# Geotechnical Exploration, Inc.

**Job No. 21-13556**

Subject: **Addendum to the Report of Preliminary Geotechnical Investigation and Geologic Fault Investigation and Response to the City of San Diego Geotechnical Review**  
Proposed Javaheri Residence  
2072 Via Casa Alta  
La Jolla, California

### **SLOPE STABILITY CALCULATIONS WITH SLIDE 6 COMPUTER PROGRAM** *JAVAHERI RESIDENCE* **Job No. 21-13556**

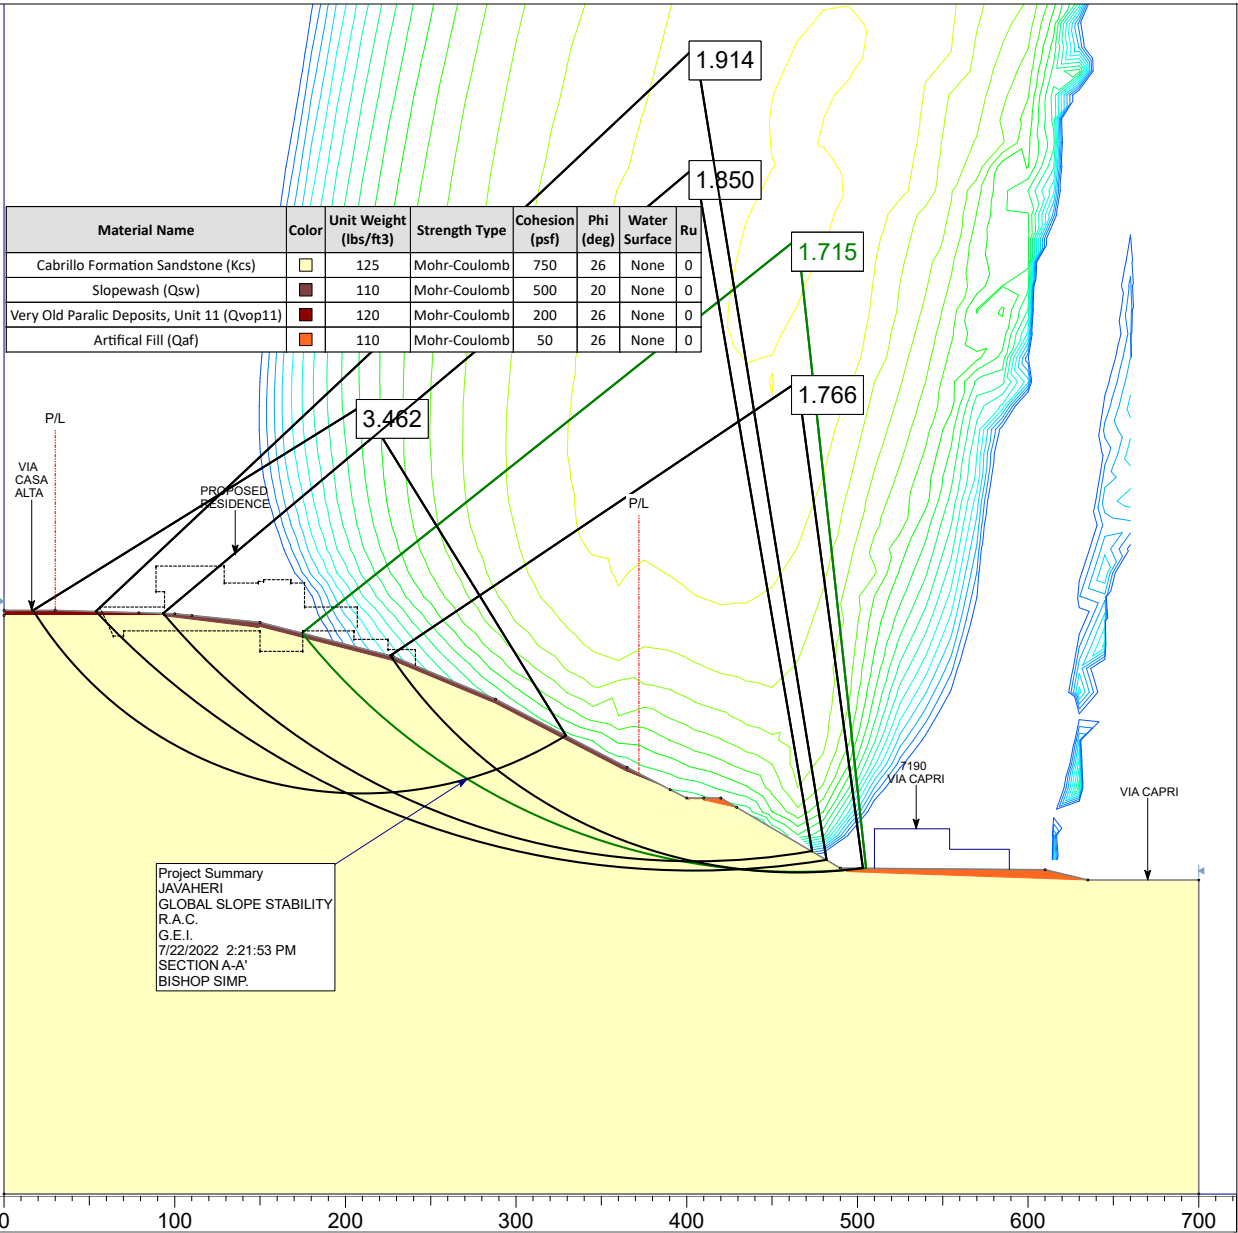
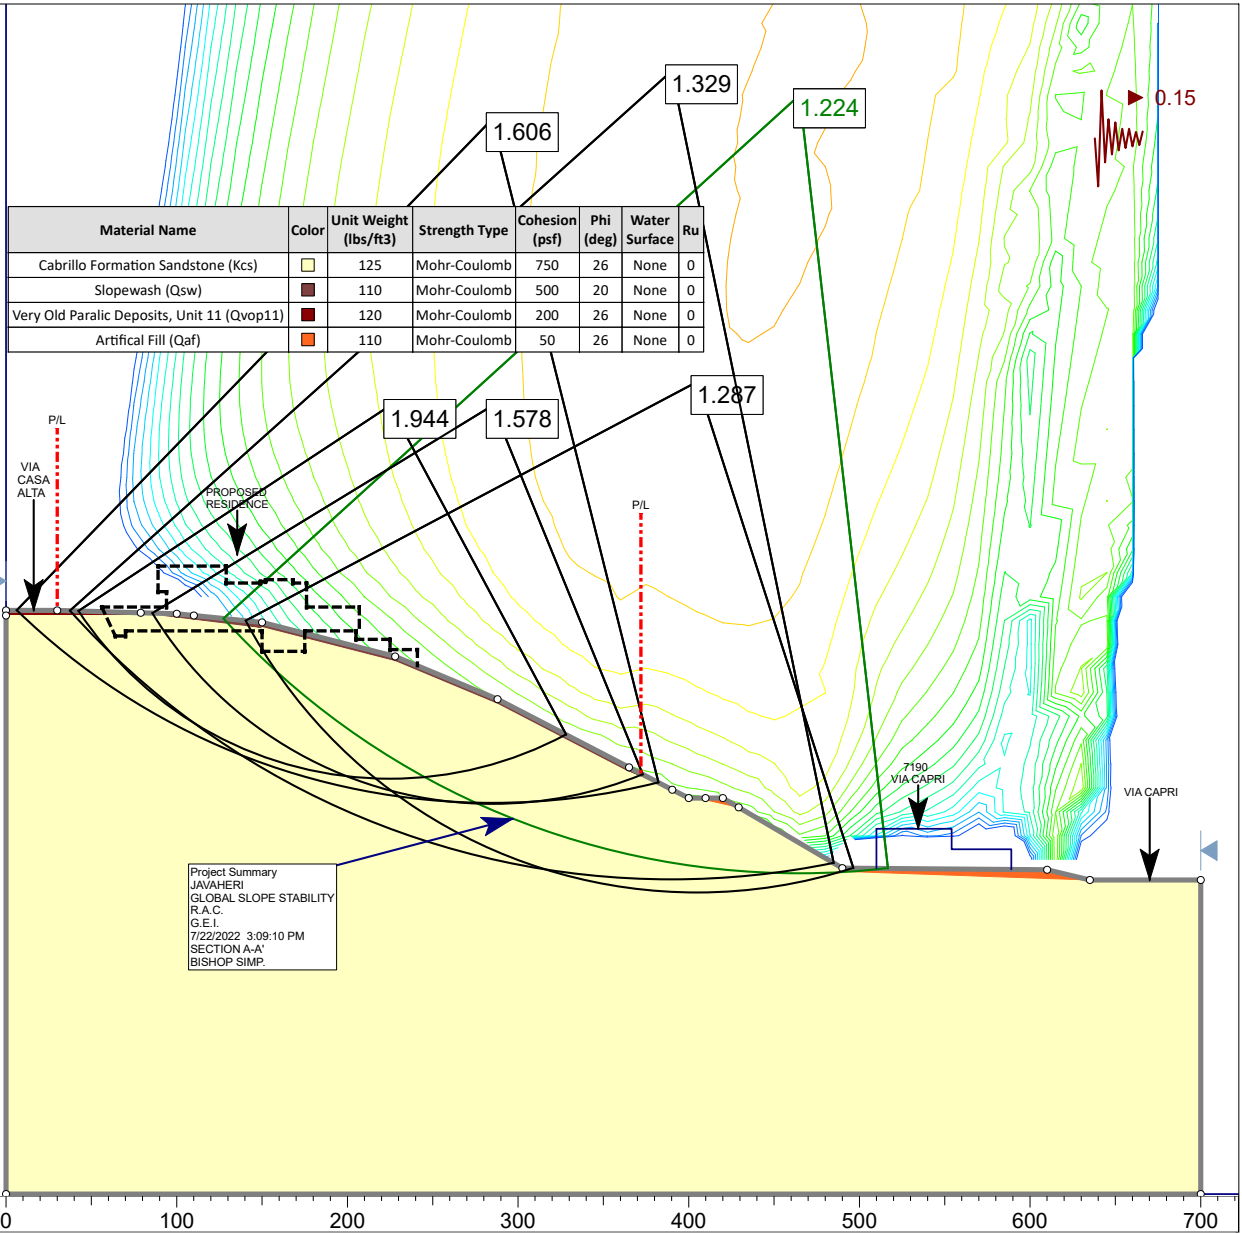
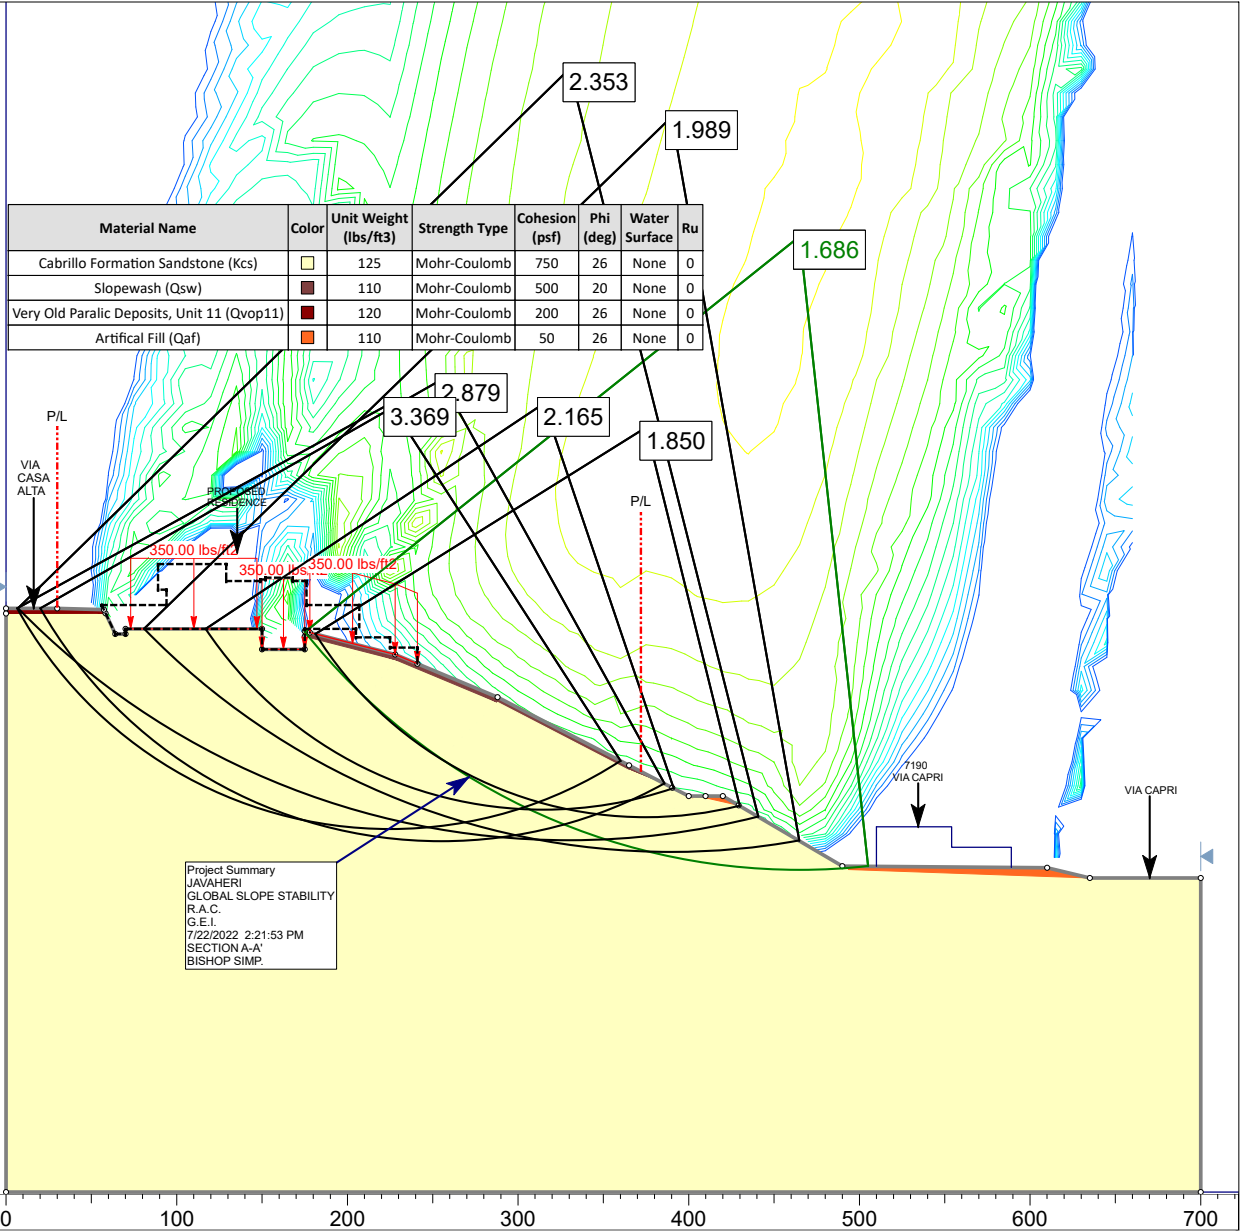
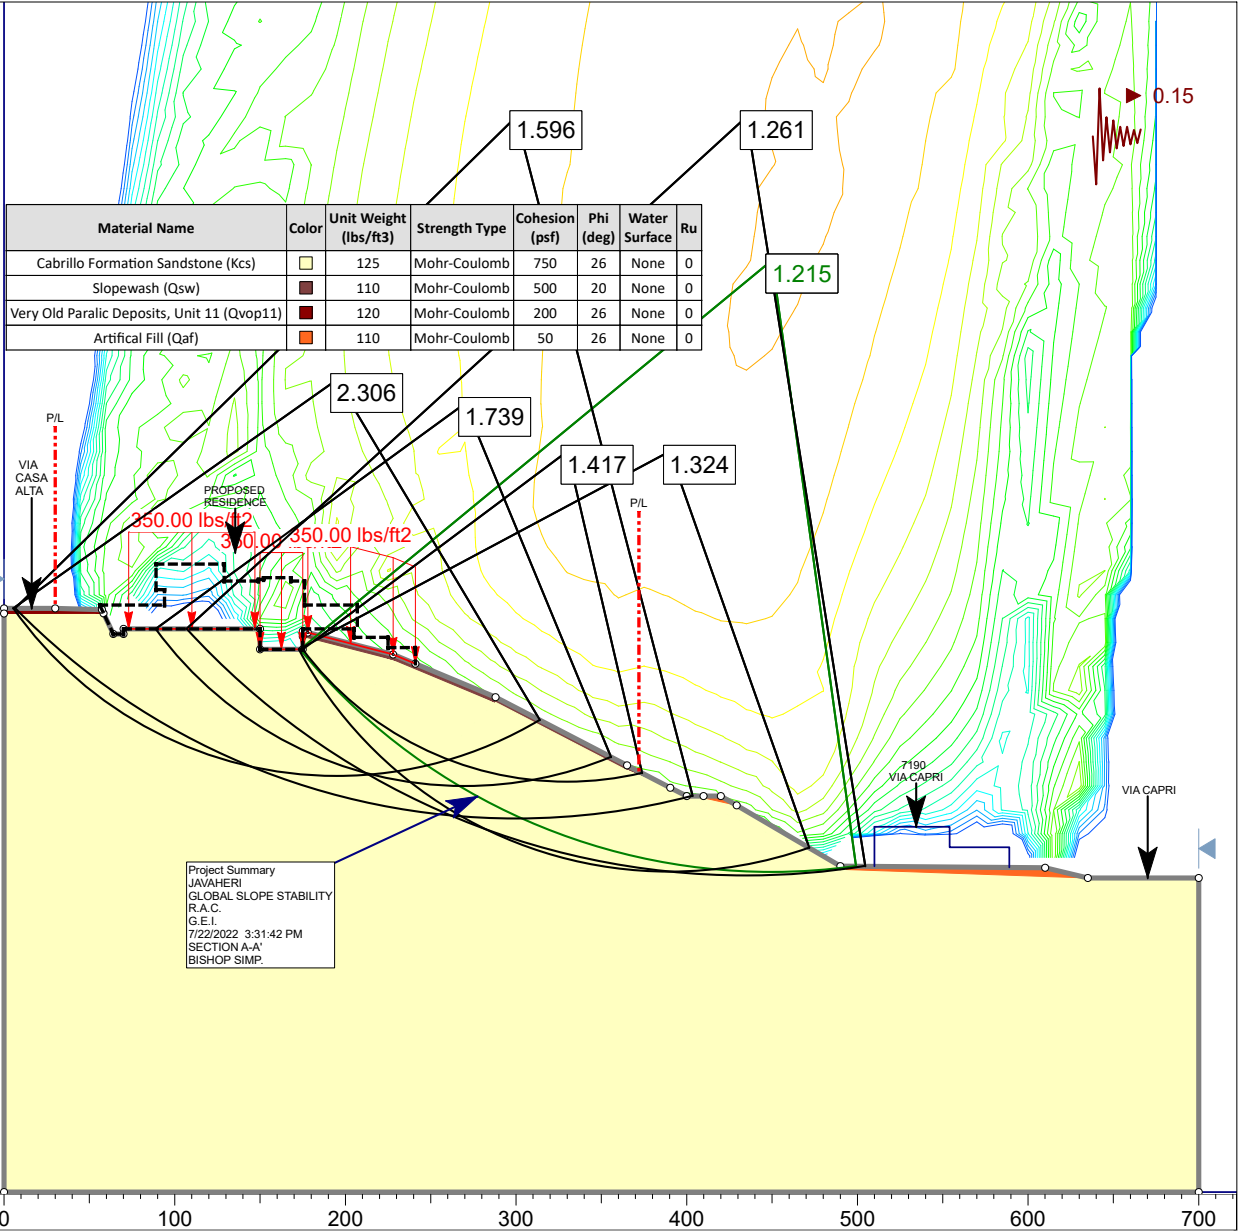
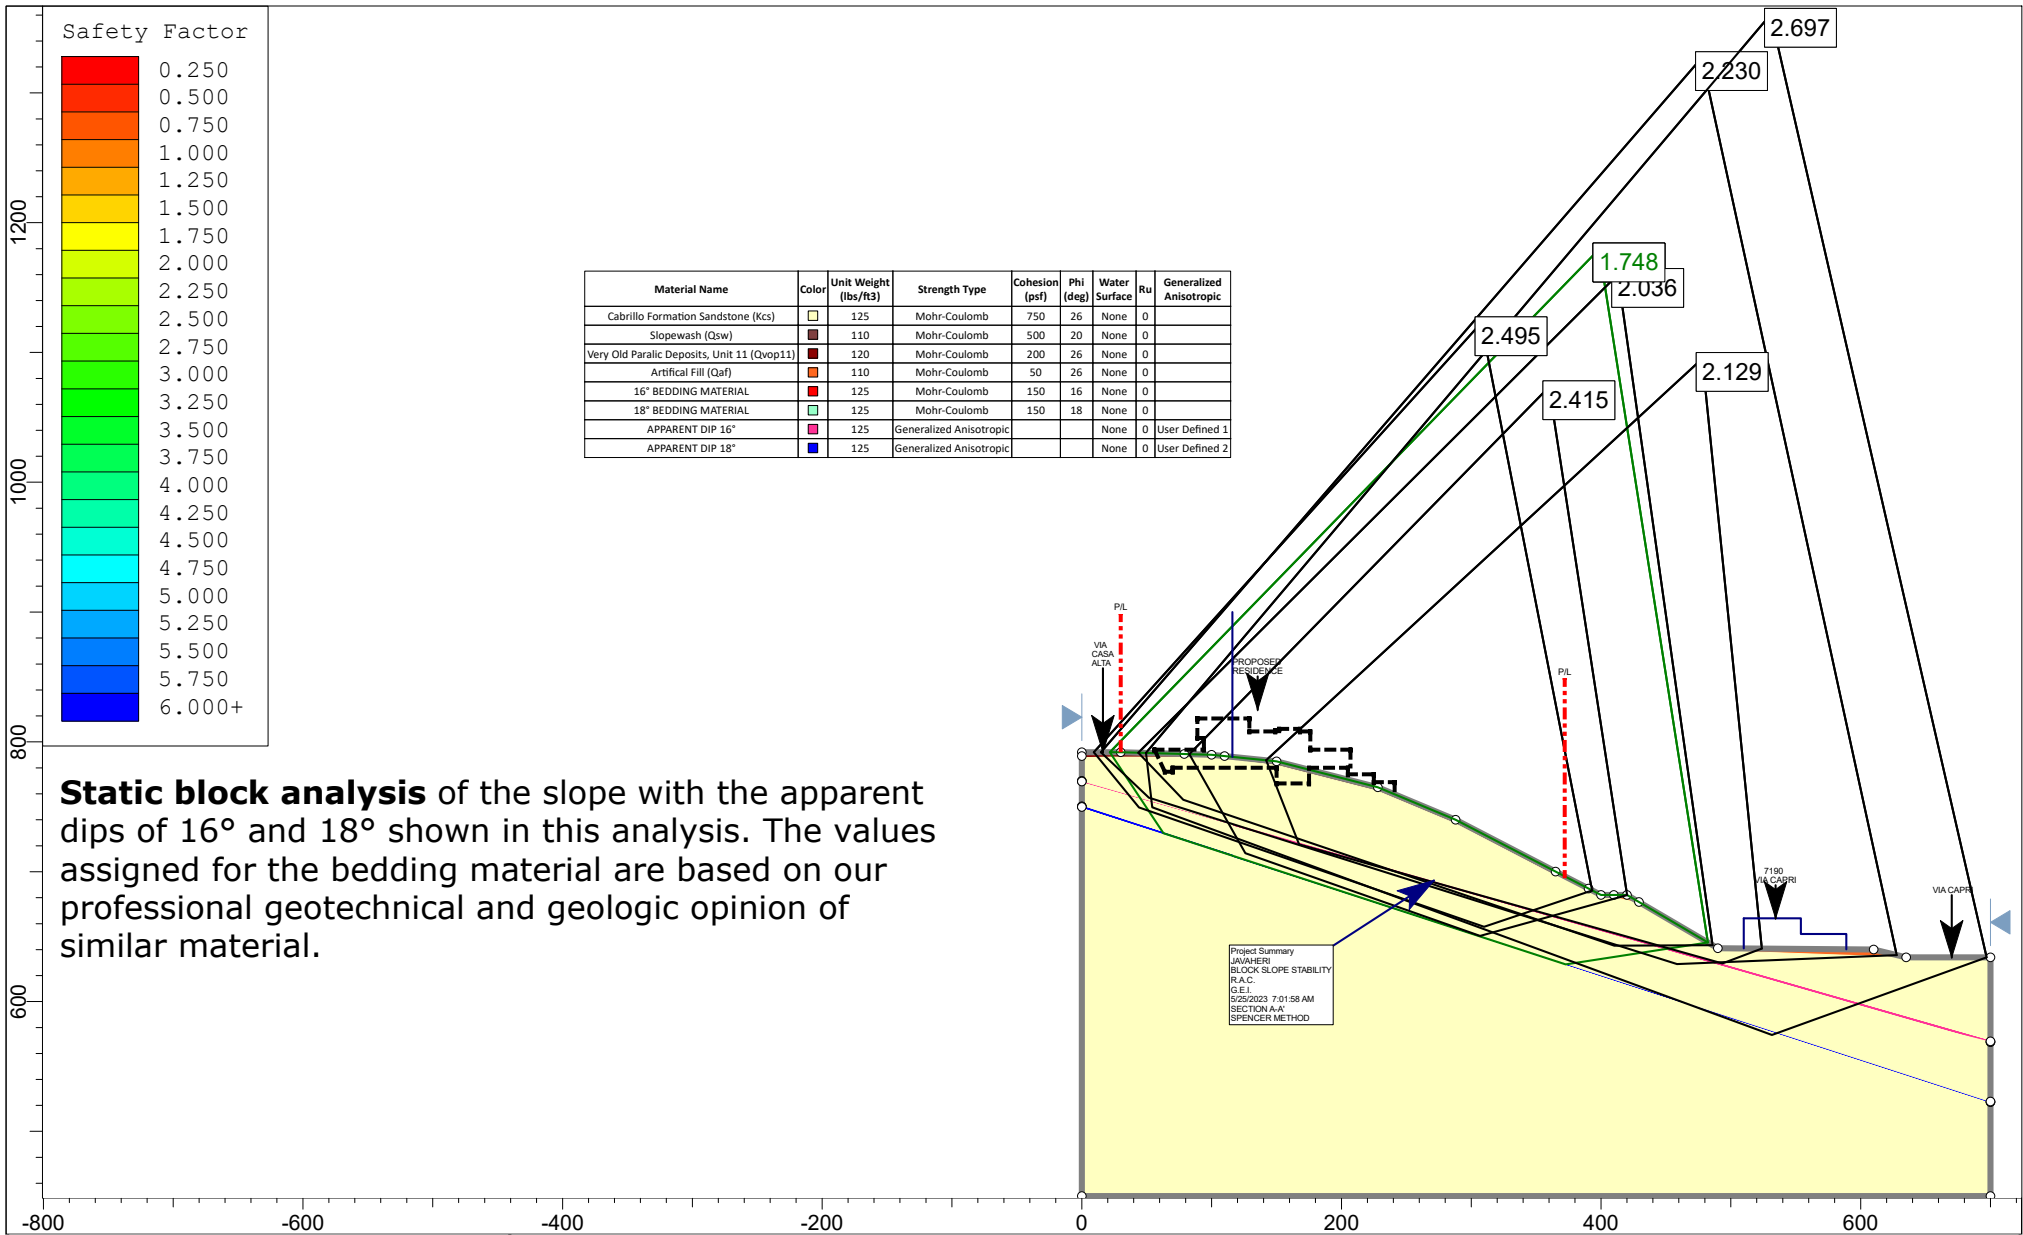
***Issue No. 9:*** *Demonstrate the site will have a factor of safety of 1.5 or greater with respect to gross and surficial slope stability following completion of the project. Provide slope stability analyses consistent with the geologic cross sections. (From Cycle 2)*

**Issue No. 24:** *The project's geotechnical consultant should clarify if their stability analysis presented in the submitted report included site-specific bedding and geologic structure data. As per the City's Guidelines for Geotechnical Reports, describe the stability analysis and discuss the results. The description should include the method of analysis, specified material profile, and specified search areas for critical failure paths. Where multiple slope stability analyses are conducted, a tabulated summary of the analyses and results should be provided. (New Issue)*

**Response:** The slope stability analysis, presented here as Appendix A, includes site-specific bedding and geologic structure data as well as the method of analysis, specified material profile, and specified search areas for critical failure paths. A tabulated summary of the analyses and results is also provided in Appendix A.

The static gross and surficial slope stability factors of safety were calculated and yielded a factor of safety value above 1.5 and greater. In the block analysis, values were assigned to bedding material for the 16- and 18-degree apparent dips as shown:

Once the static gross stability was determined, a seismic analysis was performed for the same analyzed sections. The seismic analysis yielded a factor of safety value above 1.15 as required by the City of San Diego and the State of California.
